TOWNSHIP OF FRANKLIN
Board of Adjustment
Agenda
Thursday, April 2, 2026

The subject site is a car wash recently-opened at the corner of Route 27/ Sinclair Blvd. The applicant seeks to place a freestanding along the site's frontage (sign detail – figure 4). The requested variance is as follows:

Figure 5: Submitted plan

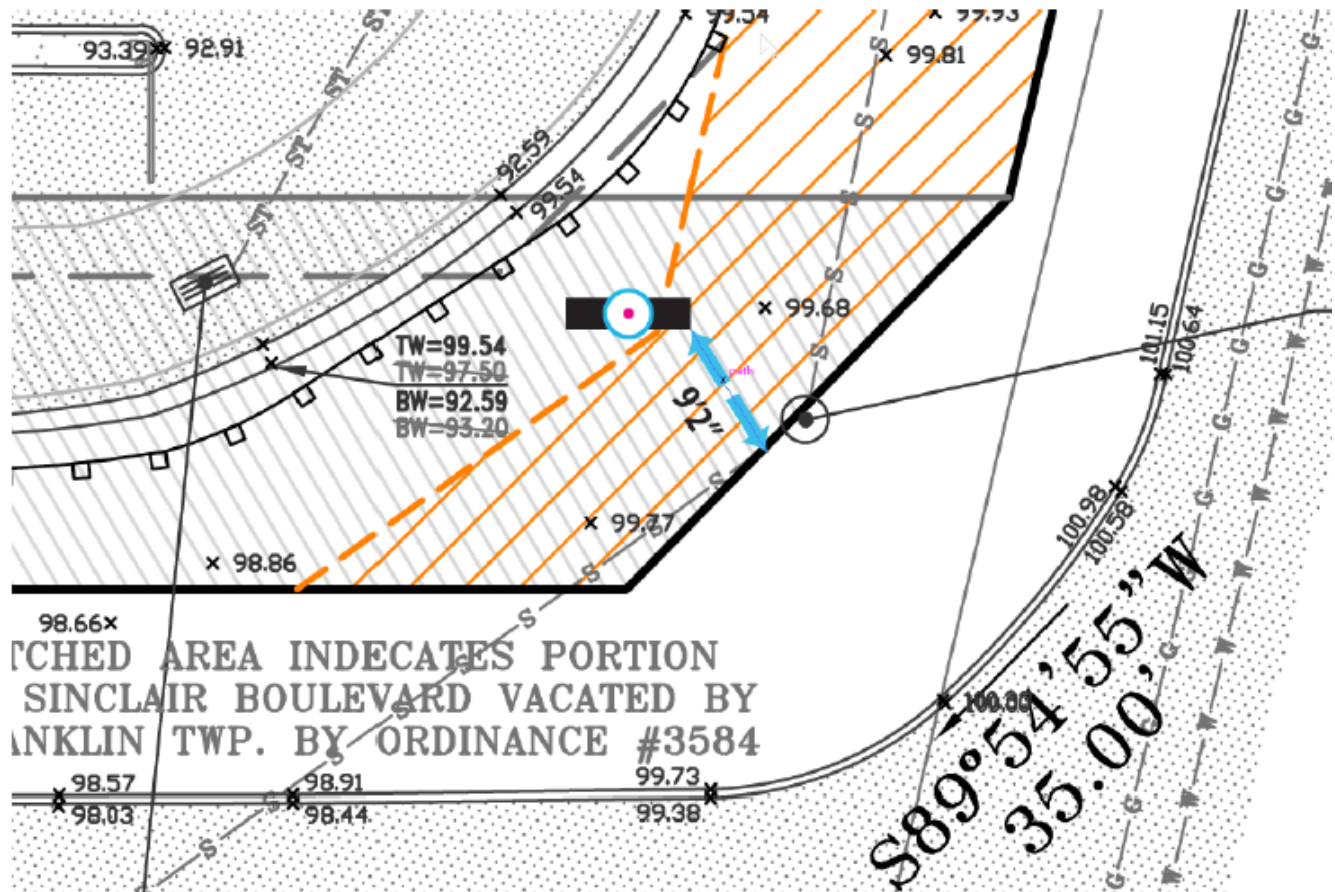
3. The applicant should clarify whether the sign placement/ height would conflict with any overhead utility lines. See Figures 3, 6 and 7.
4. The applicant has placed a number of unapproved signs along the site's Route 27 frontage (including 2 "We're open" signs with posts and within the sewer easement. Have these signs been removed? See Figures 3 and 7.

Figure 6: Overhead Utility Lines on the Site

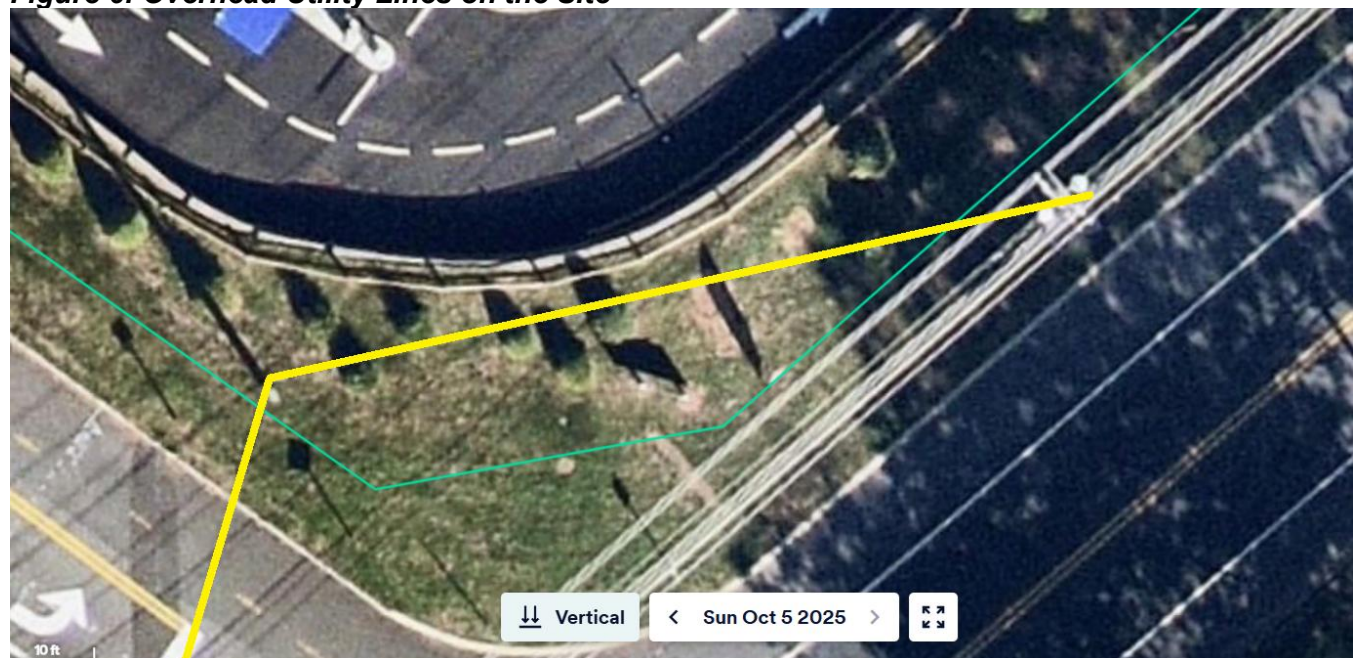
2. The Applicant needs to clarify whether any of the landscaping along the site's Route 27 frontage (which was depicted on the approved site plan) would be removed and/or relocated for sign placement/ visibility. See Figures 2, 3, 6 and 7.
